In the Matter of)
TEXAS UTILITIES ELECTRIC)
COMPANY, et al.)
)
(Comanche Peak Steam)
Electric Station,)
Units 1 and 2)

TESTIMONY OF NANCY H. WILLIAMS
IN RESPONSE TO CASE QUESTIONS OF
FEB. 22, 1984 TO CYGNA ENERGY SERVICES

Comanche Peak ASLB Hearings
Response to CASE Questions
Question No.: Doyle #1
Exhibit No.: 891, 894, 897

FIGURE D2-1

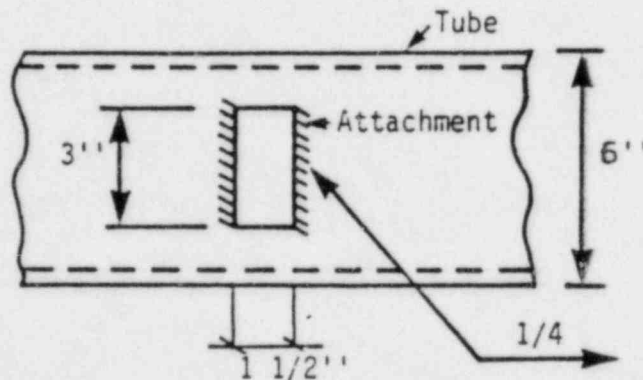
Punching shear check for Support No. RH-1-062-002-S22R.

APPLIED AXIAL LOAD = 5092 LBS.

Figure 1

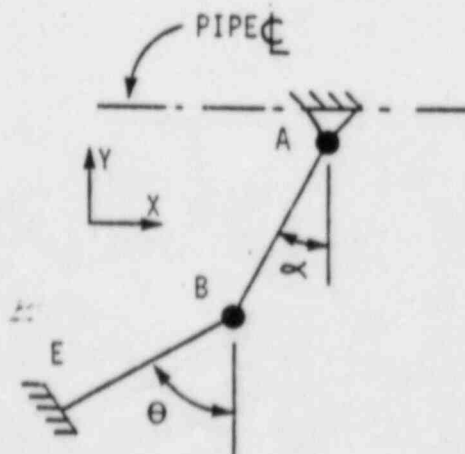
The stability characteristics of a structure under the action of compressive loads can generally be separated into three categories. These include rigid body modes of instability, Euler column buckling, and beam-column effects. For the purposes of discussion, the three support configurations in question (CASE Exhibits 891, 894 and 897) can all be idealized to the basic configuration shown in Figure 1, wherein the x component of reaction at A is provided by frictional clamping forces. For this basic configuration, the rigid body modes of instability generally account for the overall stability characteristics of the entire structure, while Euler column buckling and beam-column effects are confined to the individual members.

The rigid body mode of instability can be initiated in three ways: (1) when the clamping force at A is insufficient to develop the lateral (x) component of frictional force necessary to prevent sliding; (2) when the clamping force at A is insufficient to develop the resisting torque necessary to prevent the clamp from rotating; and (3) for the specific case of alpha equals theta, when the cantilevered member BC does not provide sufficient lateral stiffness at point B to prevent rigid body rotation of member AB.

Euler column buckling of member AB can occur for all values of alpha and theta given in the three exhibits. The correct value of K to be used in evaluating the stability of member AB is 1.0, since the member is pinned at both ends and can therefore only develop axial loads. Similarly, Euler column buckling can occur in member BC but only when alpha equals theta. The correct value of K to be used in evaluating the stability of this member is 2.0 since the member is fixed at one end and free at the other.

Check Flange Bending
 Support No. SI-1-079-001-5325

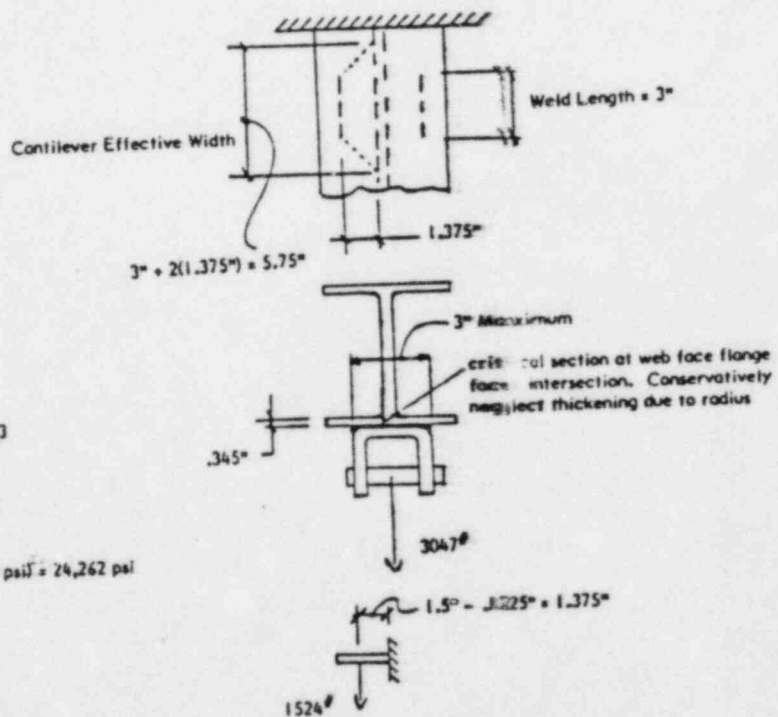
The calculation sheet attached to Exhibit 893 states that the weldment between the rear bracket and the beam flange was changed from a fillet to a flare/bevel weld. This fillet-to-flare change results in a 90 degree re-orientation of the weld lines, from perpendicular-to-parallel to the web of the wide flange. Did Cygna evaluate the additional loads on the flange?

Cygna judged that this re-orientation would not cause an overstress in the flange. The following calculation verifies that judgement:

Exhibit 891 (Support SI-1-325-002-S22R)

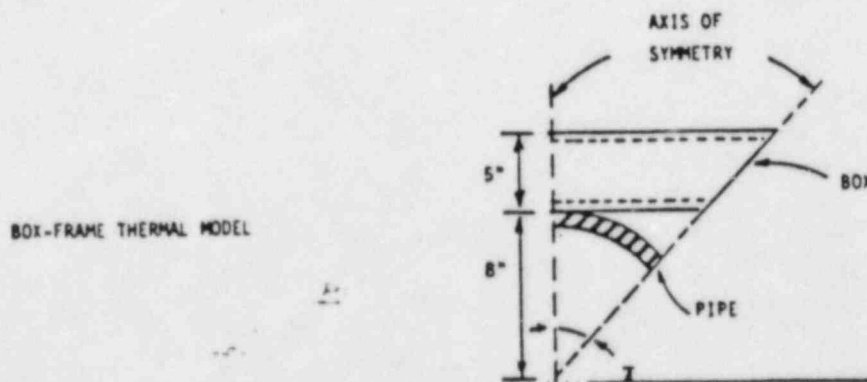
Exhibit 891 shows a box-frame enclosing a 16" diameter pipe. The design details specify a zero gap between the pipe and frame at the four points of contact. Cygna reviewers evaluated this configuration and judged that the thermal stresses would be acceptable.

To address some concerns raised during the ASLB hearing regarding this issue, Cygna performed a finite element analysis of the frame/pipe with zero gaps. Figure D15-1 shows the model. The pipe was heated to 350°F (T = 280°F) and the flexibility of both the pipe and frame were considered.

FIGURE D15-2

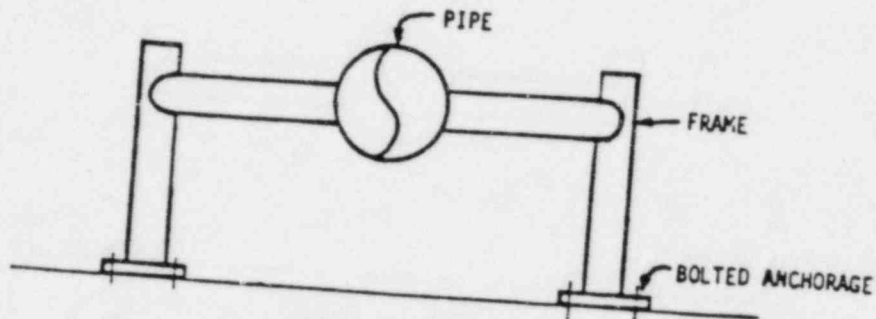
Exhibits 898 and 900 show two variations of framed supports where the pipe is welded to diametrically opposed trunions which form the horizontal member of the frame. Figure D15-2 illustrates this configuration.

Cygn reviewers considered the effect of pipe thermal expansion to have negligible impact on the support design since the stresses induced in the support result from constraint of free end displacements. Under these conditions the Code allows a 200% increase in allowable stress when the mechanical levels are combined with the effects of the pipe thermal expansion.

To demonstrate this conclusion, Cygn performed a hand calculation for CASE Exhibit 898 (See Attachment D15-1) which incorporate the effects of pipe thermal expansion with mechanical loads. The results of this calculation show that all stresses in the frame and base plate are below the allowables.

FIGURE D15-3

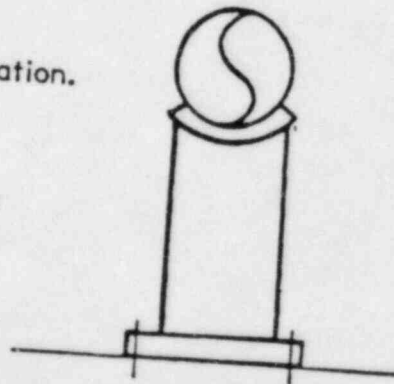
Figure D15-3 illustrates this configuration.

By inspection, thermal radial growth of the pipe is primarily unrestrained. A secondary restraint will develop at the bimetallic weld due to thermal gradients and the material differences. Cygna's reviewers judged the effect of this secondary restraint to be negligible.

Figure W3-2

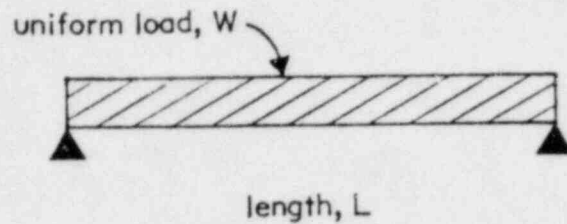
To evaluate the impact of this error in wall thickness, Cygna increased the pipe stresses by the linear proportion 0.5/0.375. Please address the following:

Dead weight stresses due to the pipe itself are unaffected as its wall thickness decreases. This is shown below for a simple beam:

The maximum deadweight bending stress (σ_D) in Figure W3-2 is:

Exhibit 902

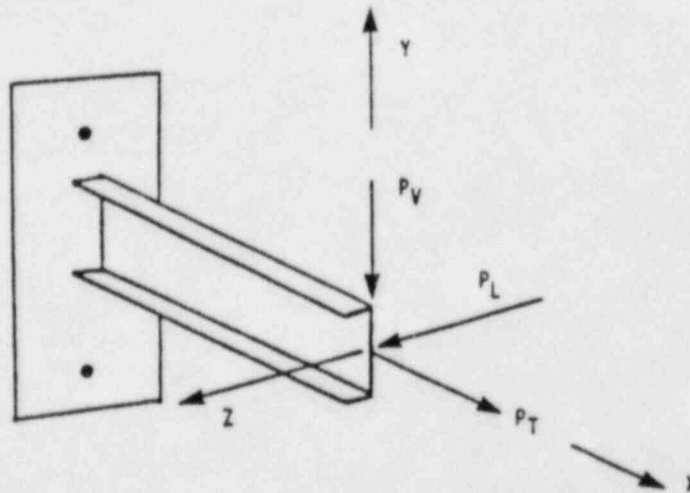
The calculation in question concerns the analysis of the two-bolt baseplate of a Detail "E" which was installed on a riser and is utilized as a three-way restraint.

Gibbs & Hill's analysis considered a rigid baseplate which was analyzed to resist rotations about the Y and Z axis. Gibbs & Hill's analysis showed that compression against the concrete provides sufficient resistance in conjunction with the tension in the anchor bolts.

Gibbs & Hill Revised Calculation	=	.584
Cygna Baseplate Analysis	=	.464

ISOMETRIC VIEW OF CABLE
TRAY & SUPPORTS FROM
DRAWING 2323-E1-0601-1
REF: CASE EXHIBIT 890

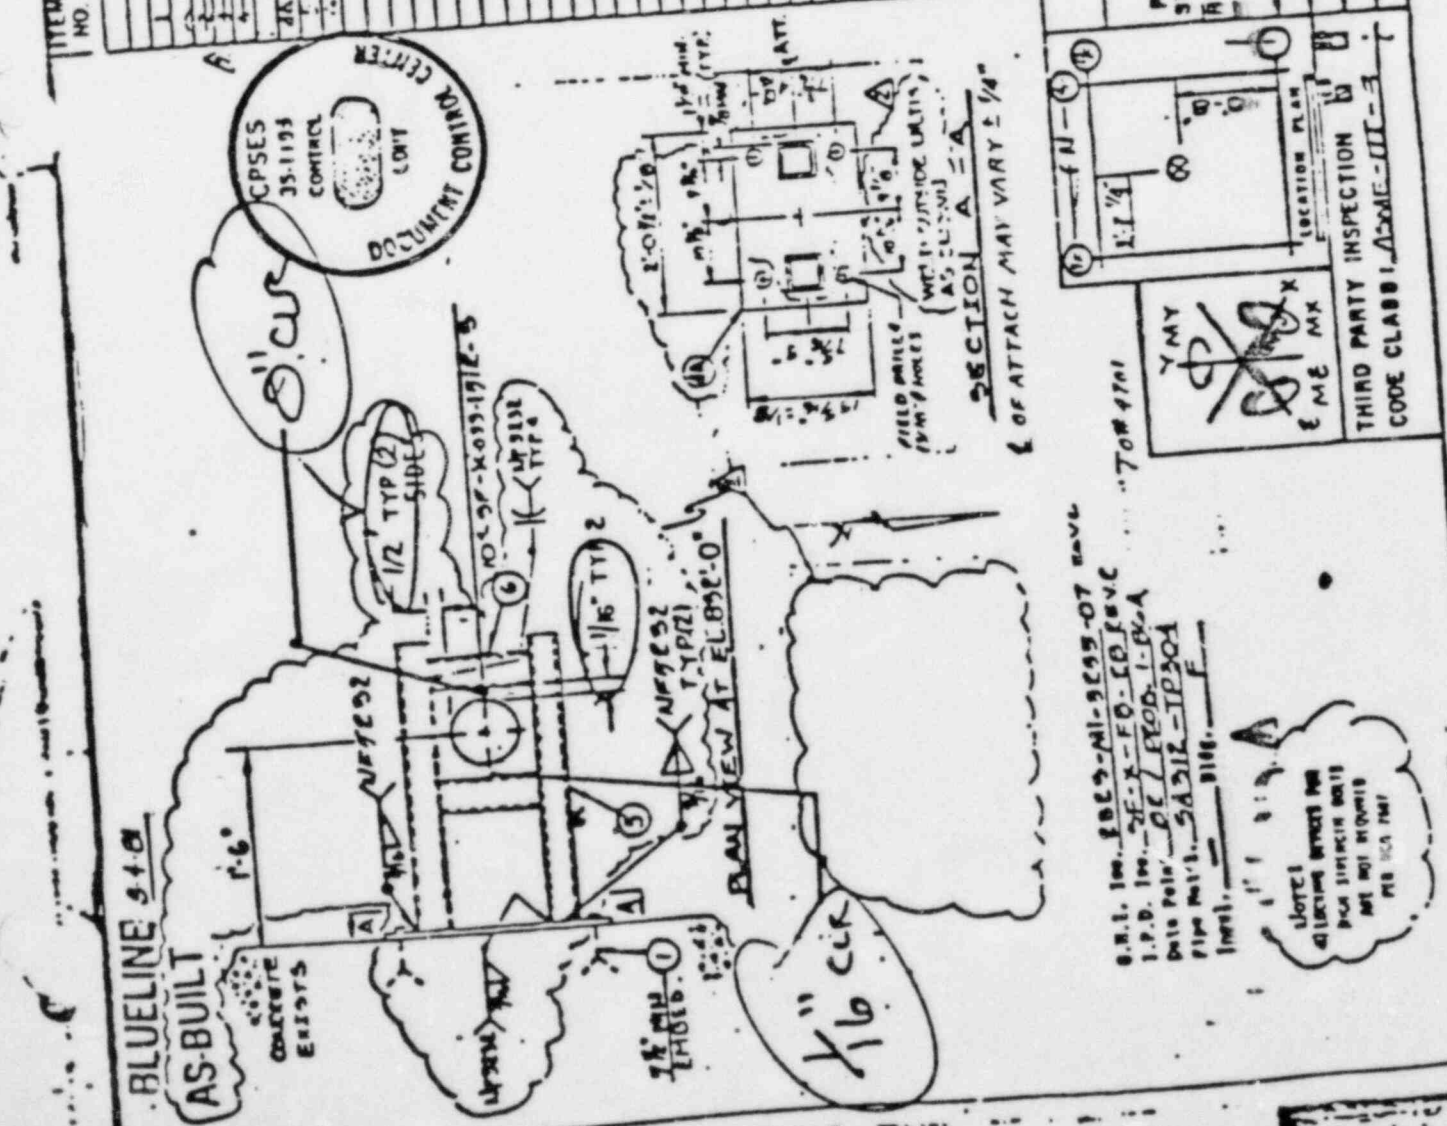
- a. Why was only 1/2 SSE considered?
- b. Why was 4% damping used?
- c. How were the dynamic effects of the trays included in the analysis?
- d. On Drawing 2323-EI-0601-01, there appears to be no means for transferring load around the cable tray bend. Please discuss this.

- d. As shown in Attachment W5-5, the tray system in question is adequately supported. An axial restraint is provided near each bend. The schematic in Attachment W5-5 is taken directly from Drawing 2323-EI-0601-1 (CASE Exhibit 957).
- e. Gibbs & Hill calculation SCS-113c, set 3, addresses the longitudinal restraints discussed in item (d).
